## ADDENDUM #1

Reference: Technology Building Re-roof  
Southern Utah University – Cedar City, Utah  
Project No.09257730

**SOUTHERN UTAH UNIVERSITY  
TECHNOLOGY RE-ROOF  
DFCM PROJECT # 09257730**

**ITEM #18:** (Reference Drawing D101 and A201)

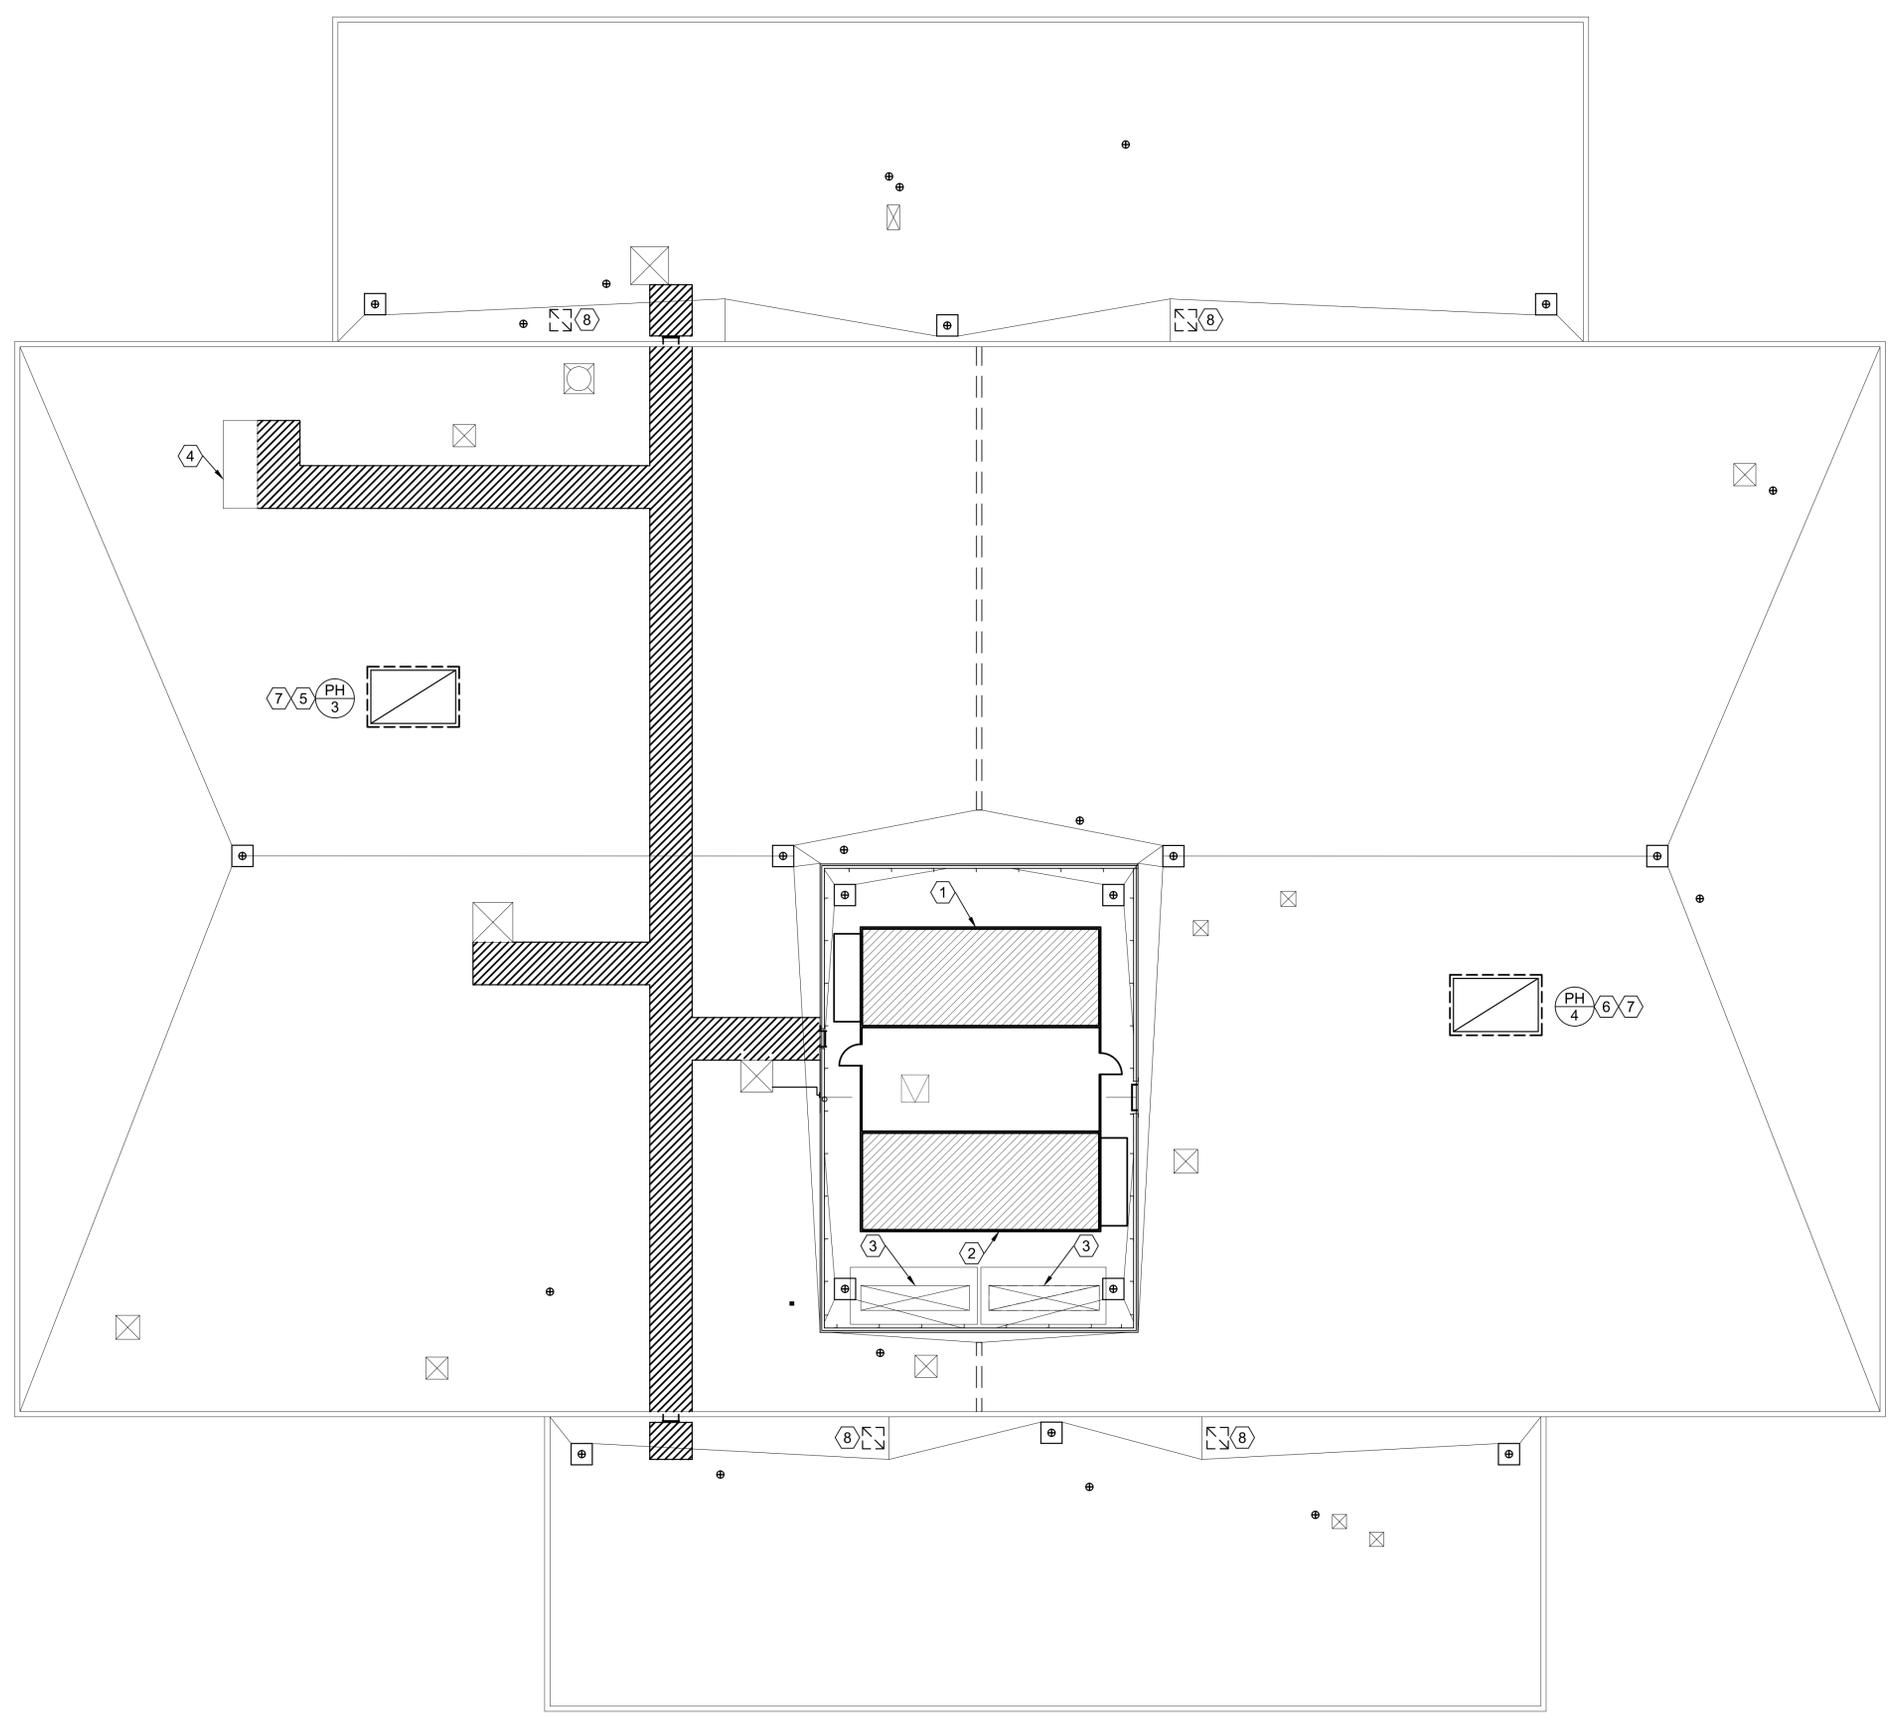
Replace Keynote #6 on Drawing D101 with the following. "Remove all existing drains and the lead and oakum connections and prepare to receive new drains".

Add to General Notes on Drawing A 201 the following: New General Note #5, "Replace all existing roof drains and existing lead and oakum connections with new 2" roof drains with either threaded or no hub connections to the existing piping. Provide new Zurn 100 roof drain w/ under deck clamp or equal by Wade, Jogan or Smith. No plastic allowed".

SHEET NO.  
ME101

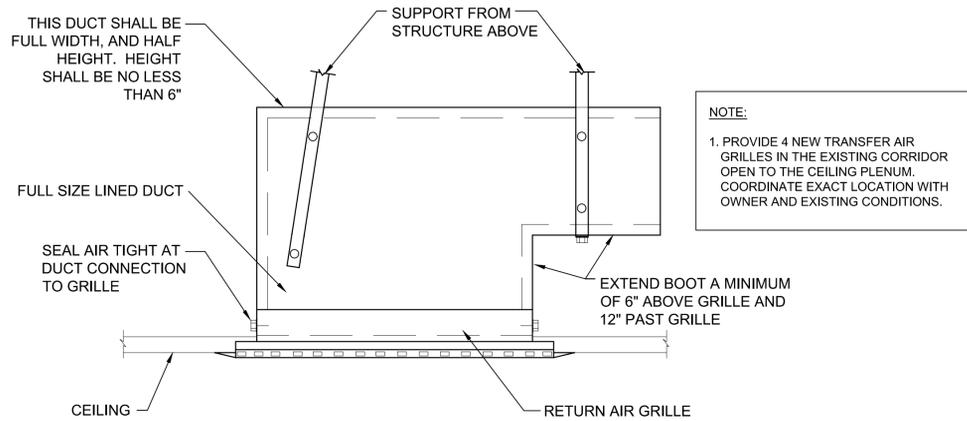
**ITEM #17:** (Reference Drawings ME101 and ME501)

Add the (2) two new mechanical drawings ME101 (New Roof Plan) and ME 501 (Mechanical Details) to the plans and specifications for the SUU Technology Re-Roofing Project.

See these Drawings for all specifics regarding the acquisition and installation of the new Relief Air unit.
